MANATEE COUNTY GOVERNMENT

SUBJECT: Invitation for Bid #05-8355-JR
John H. Marble Park Renovation / Construction

ADDENDUM #1

Asphalt RC track

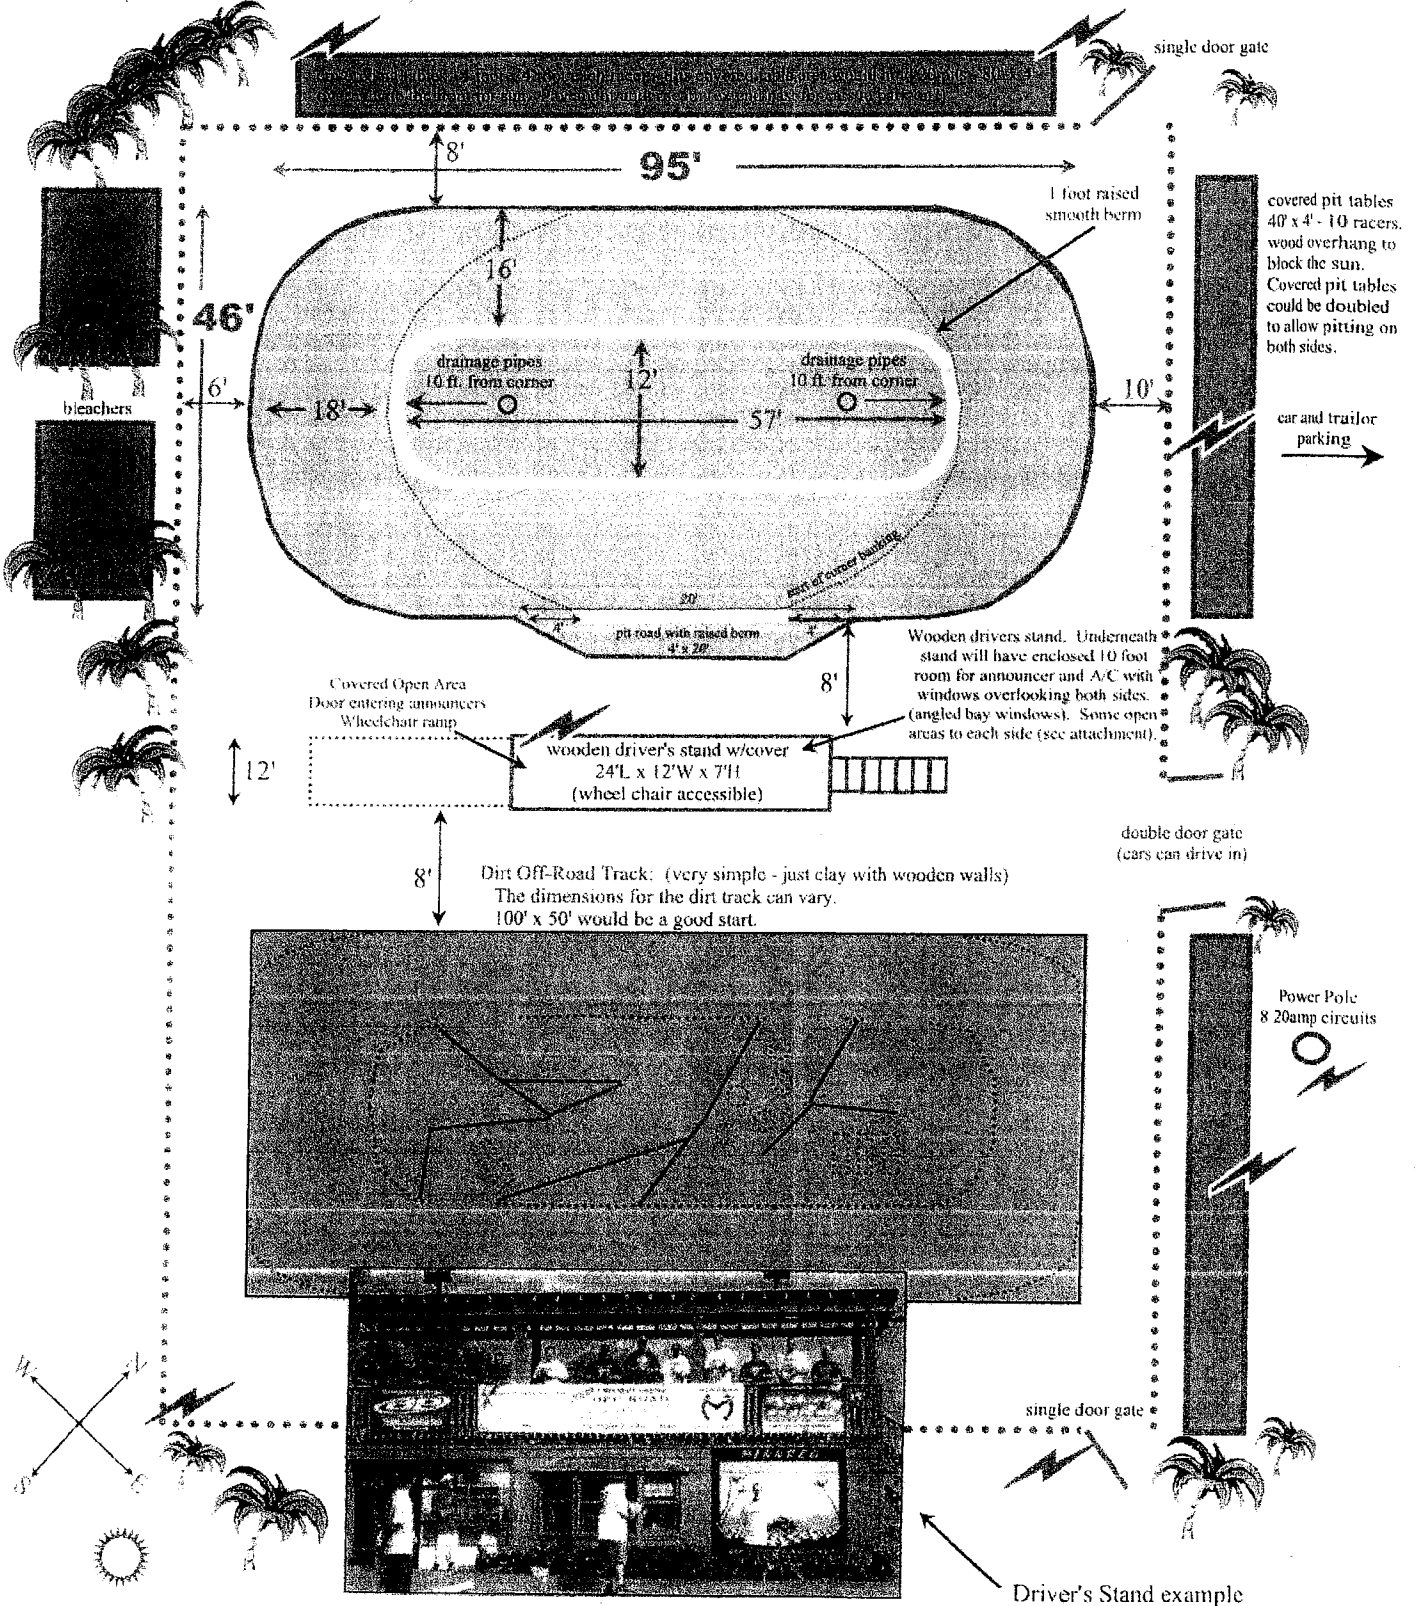
3. Should the curves be banked on the Remote Control Car Track?

1-2 degrees banking on straightaways with progressive banking in corners with smooth transition going in from straightaways.

It would be ideal to have about 8-10 degrees of banking on top of corners and almost flat on bottom of corner (1-2 degree to match straight).

Wooden outside walls with some type of fencing around track area.

Paved pit row (4 feet wide x 20 feet) with raised berm.

The car track should be built according to the attached revised specification drawings. The banking of the curves should be included in the contractor's lump sum price. The guardrails necessary for the car track will be supplied and installed by the County. See attached sketch sheets.

Yes. There will be two drains in the middle of the track, as shown on the sketch sheets provided.

Initial Plan (asphalt oval track):

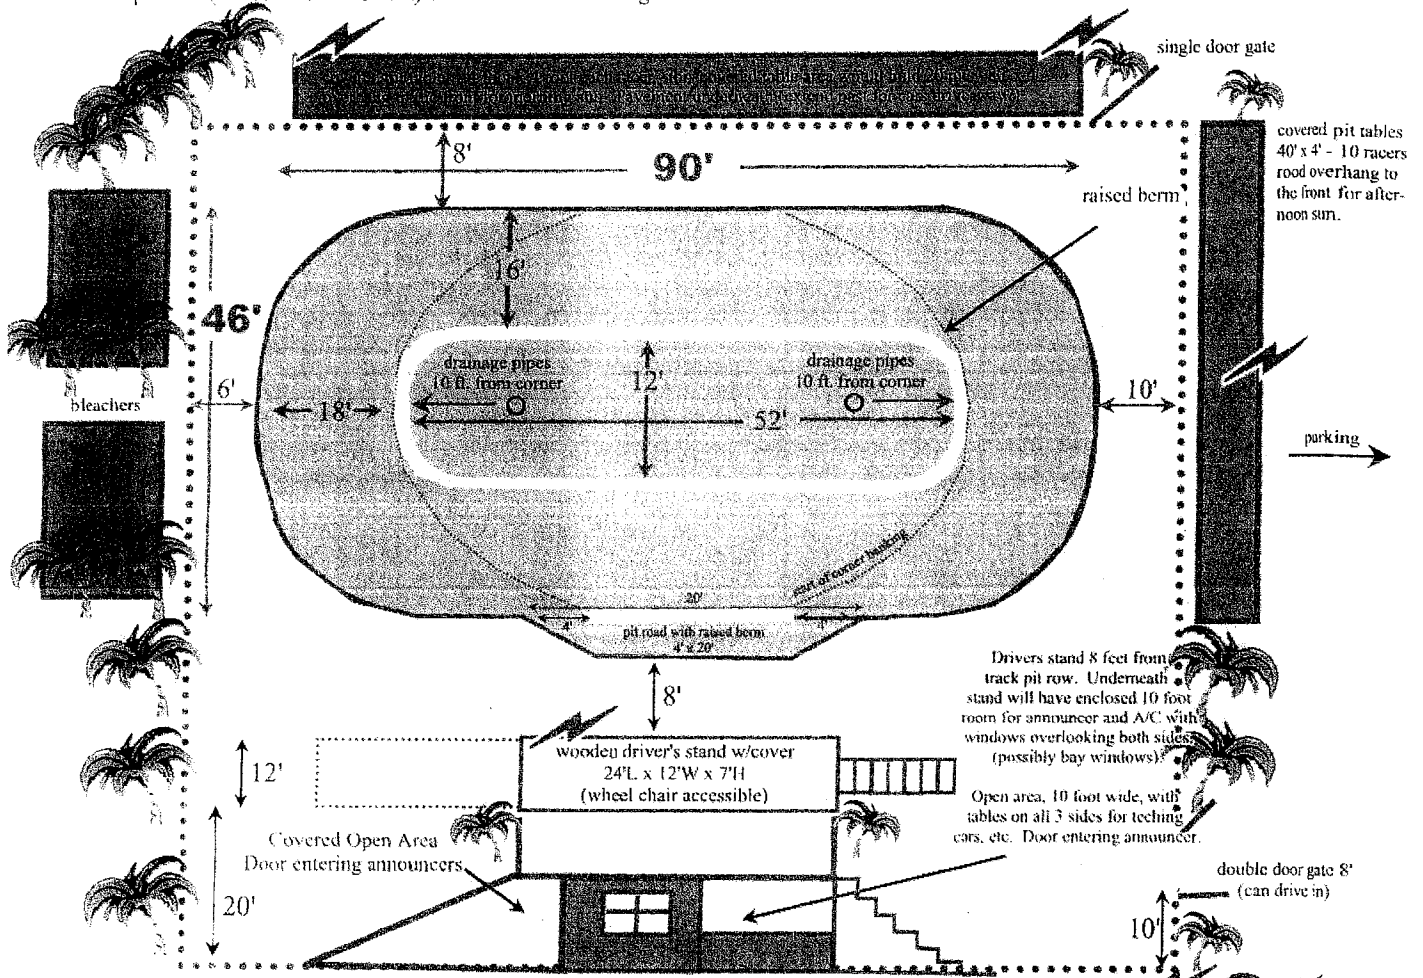
1-2 degrees banking on straightaways with progressive banking in corners with smooth transition going in from straightaways.

It would be ideal to have about 8-10 degrees of banking on top of corners and almost flat on bottom of corner (1-2 degree to match straight).

Wooden outside walls with some type of fencing around track area (10 feet from track).
 Paved pit row (4 feet wide x 15 feet) with raised berm. Angle wood near entrance / exit.
